WEST ABQ SELF STORAGE

**Re: West ABQ Self Storage
99999 Woodmont NW (Paseo Del Norte & Woodmont)
Conceptual Traffic Circulation Layout for DFT Approval
Engineer's Stamp 8-1-25 (C09D022) TRANS-2025-00212**

**RE: West ABQ Self Storage
99999 Woodmont Ave NW
Conceptual Grading Plans
Engineer's Stamp Date: 8/1/25
Hydrology File: C09D022
Case # HYDR-2025-00273**

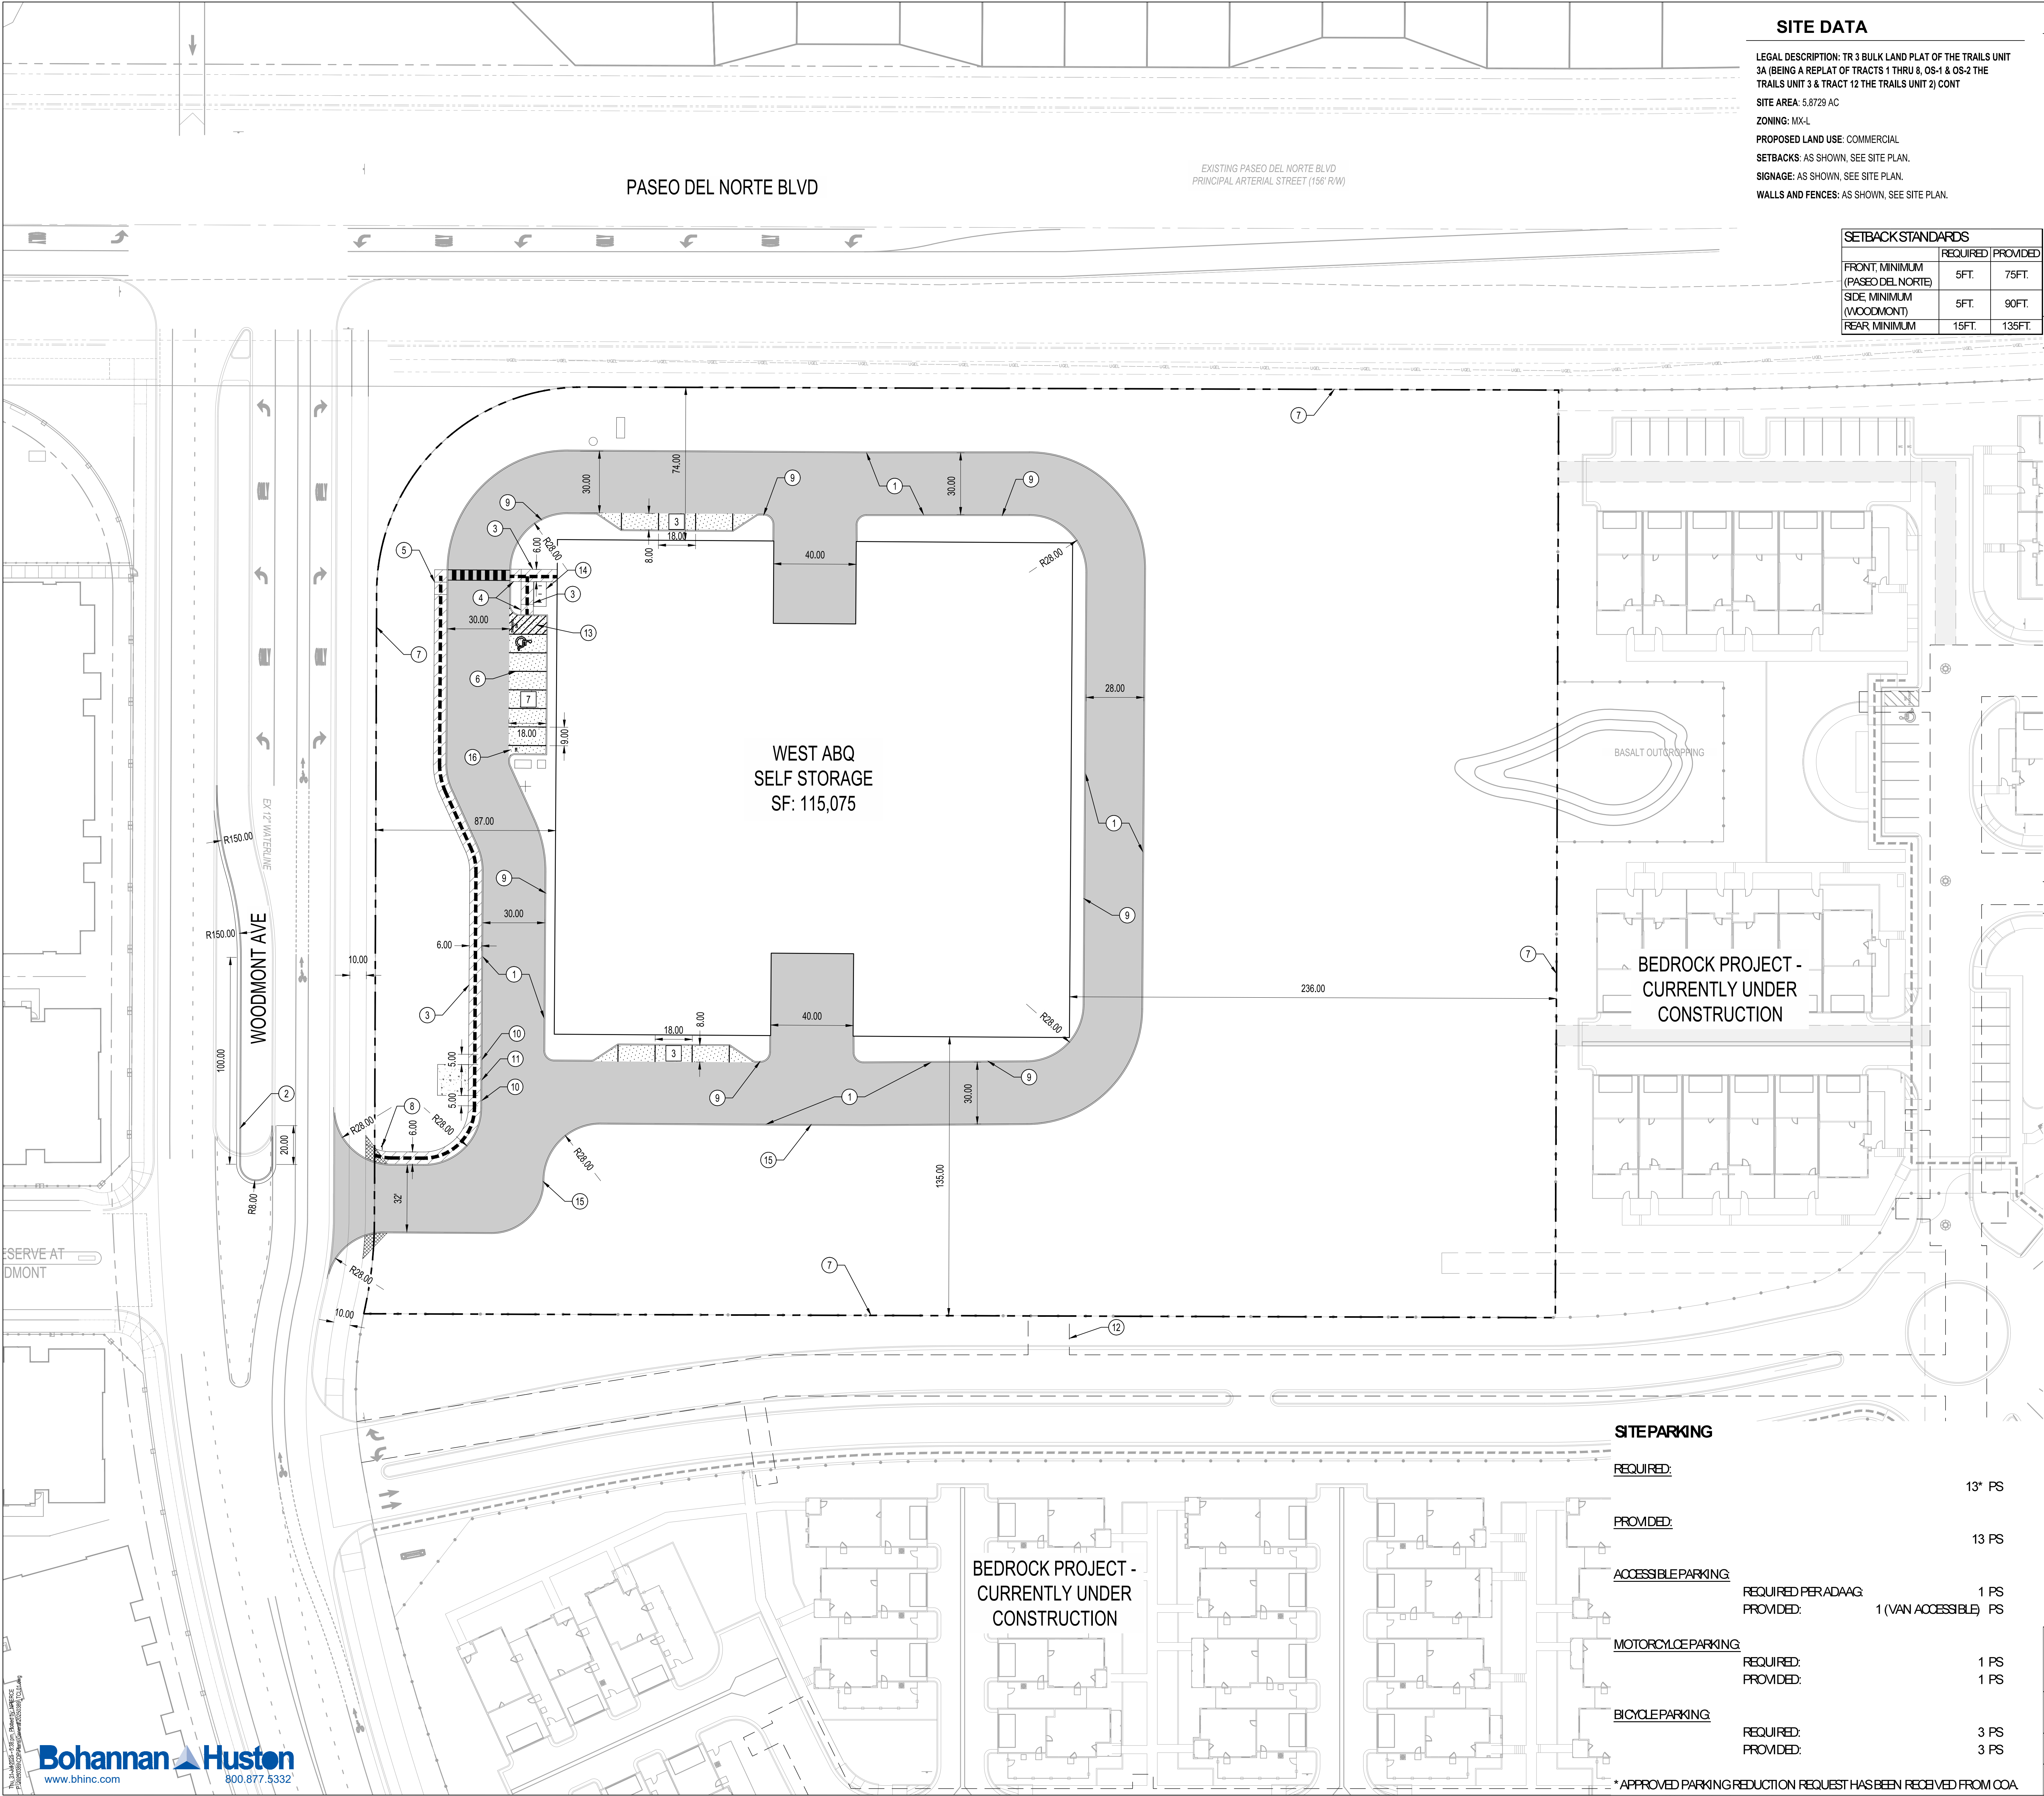
The conceptual TCL submittal received 8-1-2025 is approved for DHO and/or DFT submittal. When submitting this project through the building permit process, a full Traffic Circulation Layout will need to be submitted and approved prior to building permit. **When submitting TCL for building permit approval, please ensure that:**

1-A 6 ft sidewalk, and 5-6 ft Landscape/Buffer along Paseo Del Norte is shown on the TCL plan

2- A 5 ft sidewalk, and 4-6 ft Landscape/Buffer along Woodmonte is shown on the TCL plan
3- A 5 ft sidewalk, and 4-6 ft Landscape/Buffer along Unnamed road on the south is shown on the TCL plan.

4-All the above infrastructures should be added to the IIA list and financially guaranteed.
